DEVIATION REQUEST AND DECISION FORM

Project Name : Waterbury

A deviation from the standards of or in **2.2.4.B.5 Roadway Functional Classifications and Urban/Rural Designations Urban Residential Collector and 2.3.2 Design Standards by Functional Class** of the Engineering Criteria Manual (ECM) is requested.

Deviation Exhibit 2
Saybrook Drive
Cross Section
Waterbury (LSC #204220)

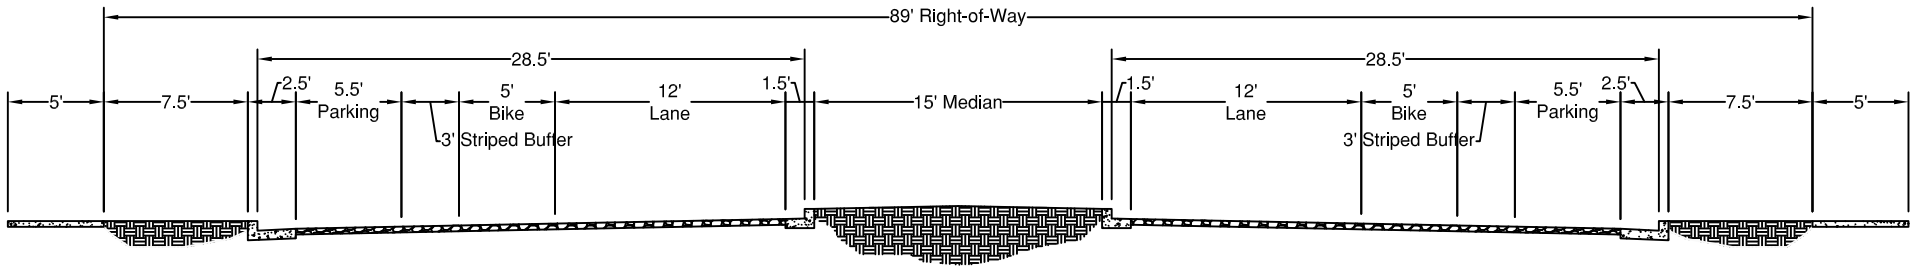
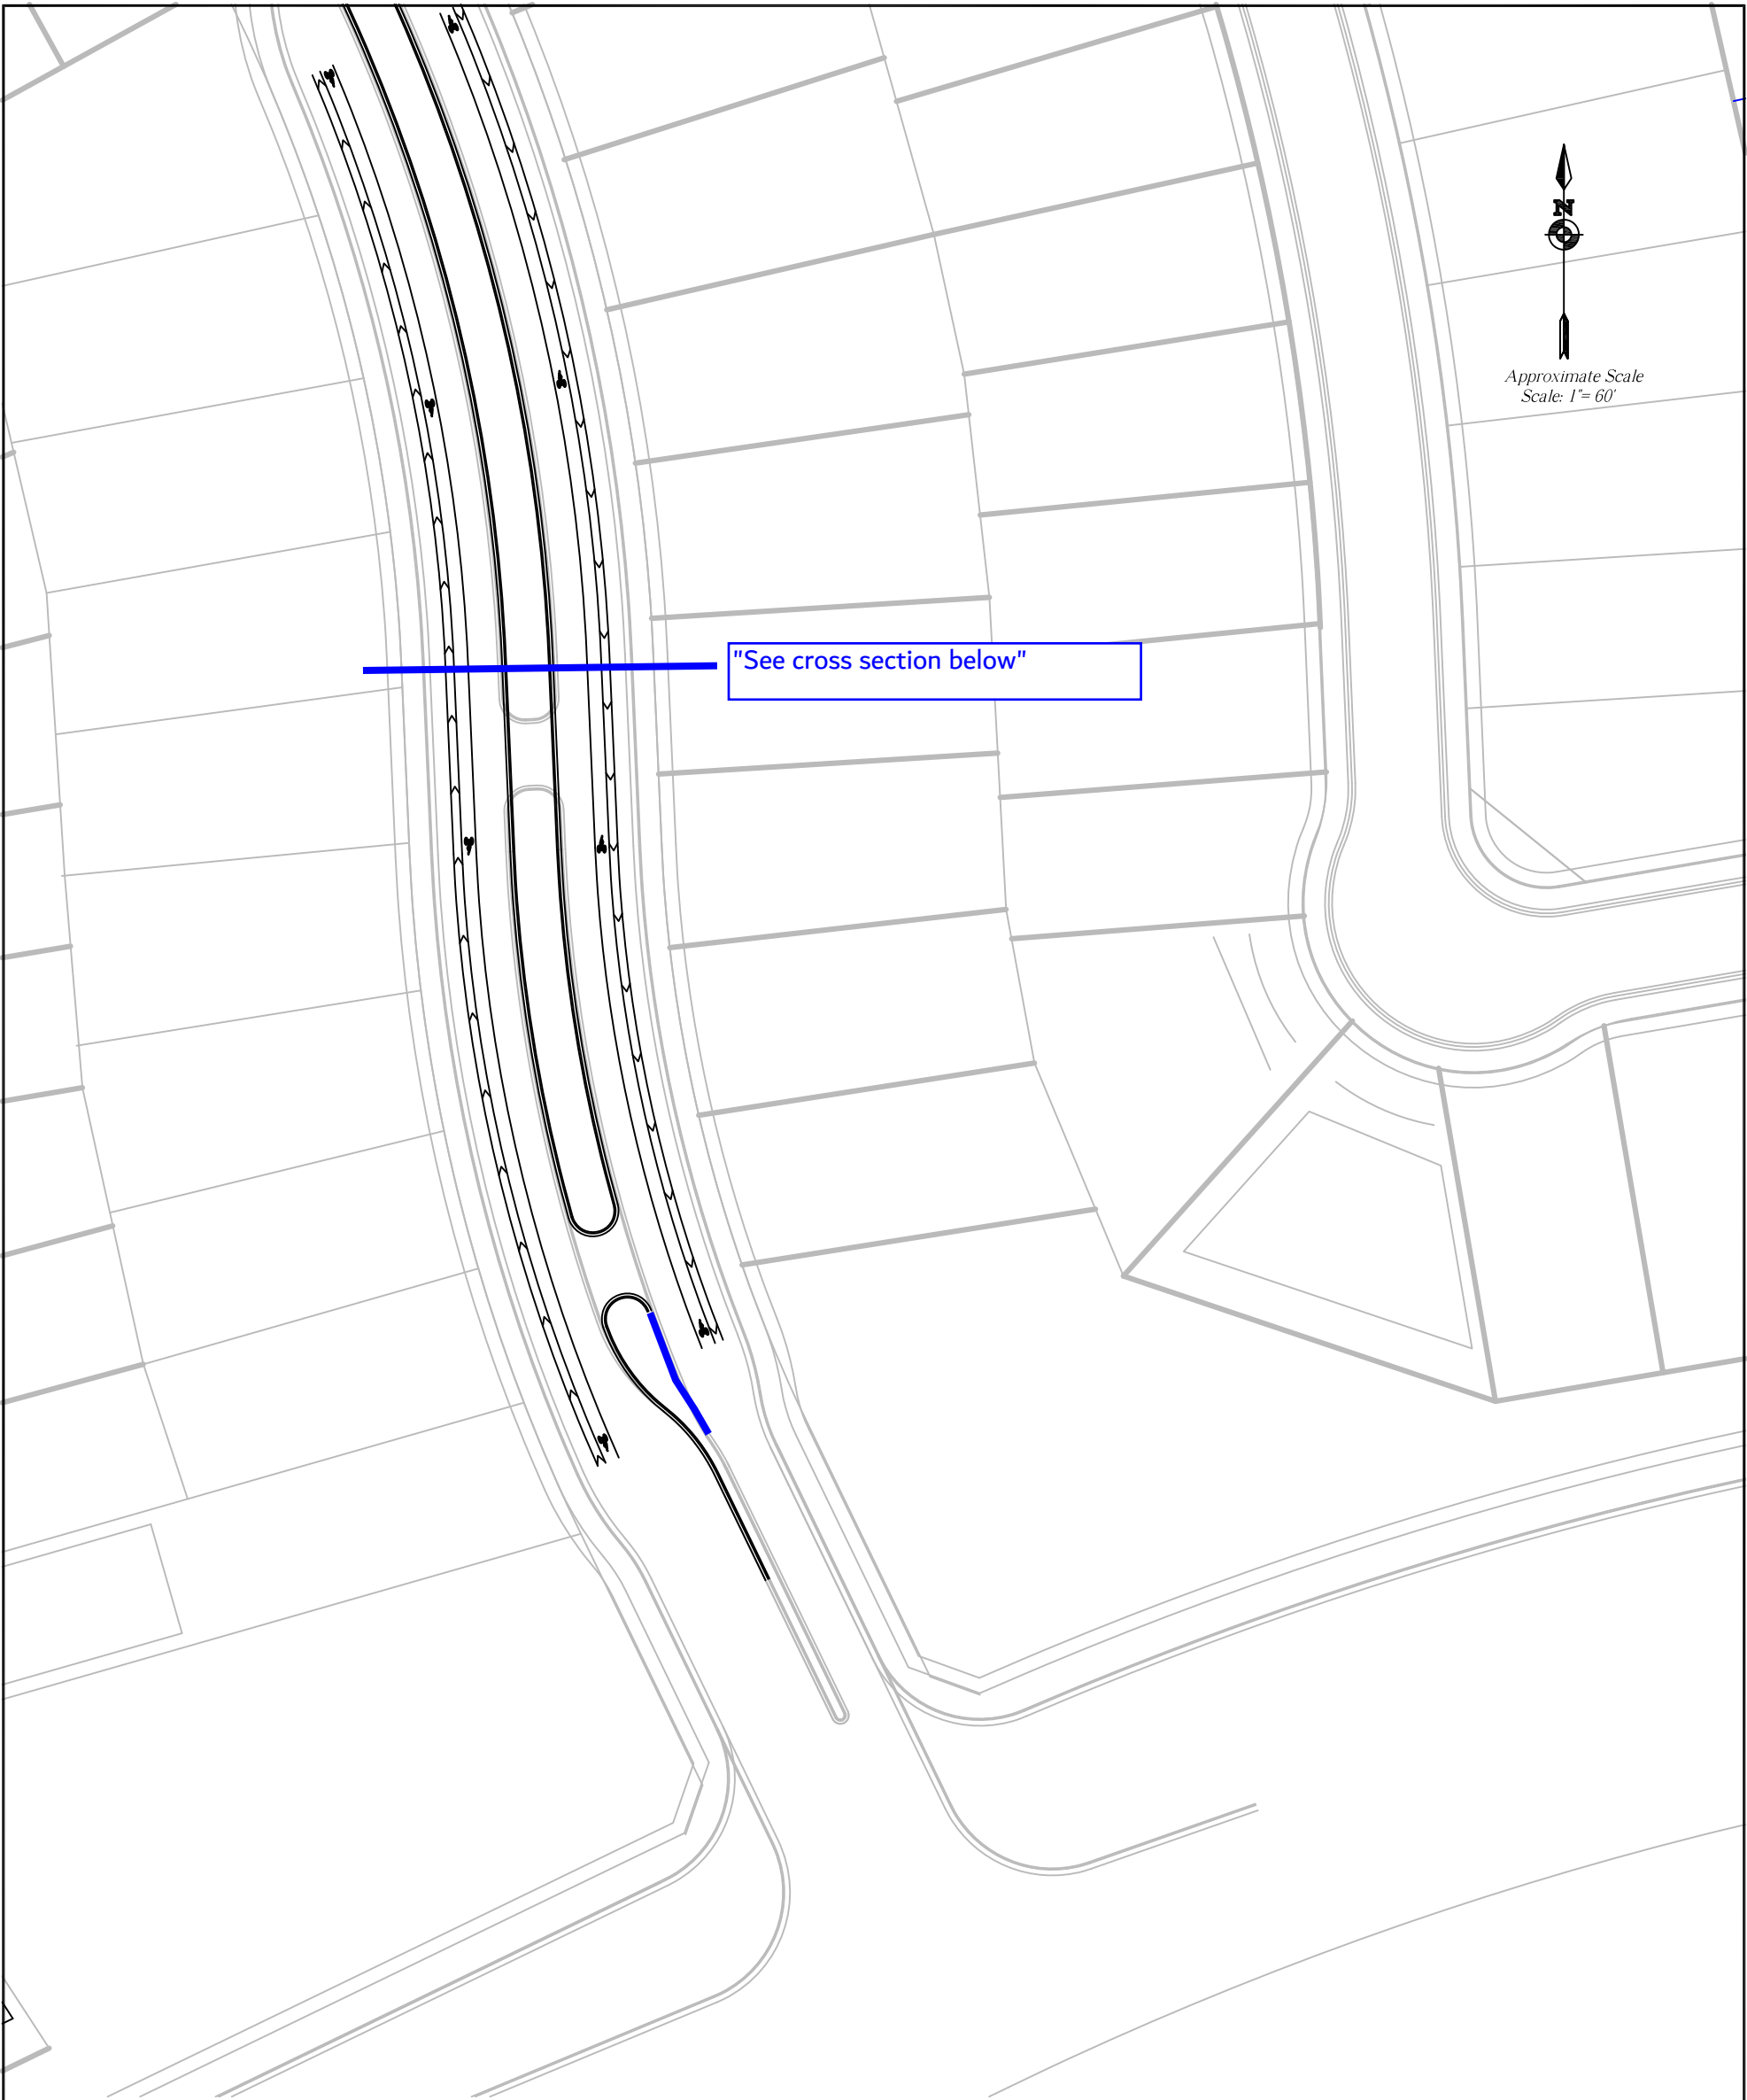
See the attached exhibit for the proposed modified cross section for Saybrook Drive.

The proposed cross section would provide for 25.5' of pavement in each direction (7.5' for parking including gutter pan, a 3' striped "buffer", a 5' bike lane, a 12' travel lane (exclusive of 1' concrete gutter plan) and a 15' median in 89' of right-of-way.

The proposed cross section will provide for on street parallel parking which is not allowed on Urban Residential Collectors based on the criteria contained in Table 2-6. The adjacent parking lane and striped buffer would provide space for drivers to back out of driveways without having to back into the through traffic lanes. The intention is that parking would be restricted in front of the driveways (obviously) and "upstream" a short distance from each driveway to allow for backing maneuver into the combined buffer and parking lane width.

The proposed median will restrict the driveways for lots adjacent to Saybrook Drive to right-in/right-out only. Residents & guests will be able to utilize the planned roundabout to the north and the proposed median opening on the south end to make U-turns to travel in the desired direction. The proposed parking lane and 3' buffer between the parking lane and the bike lane will allow for vehicles to safely back out of their driveways without the need to back into the bike lane or travel lane.
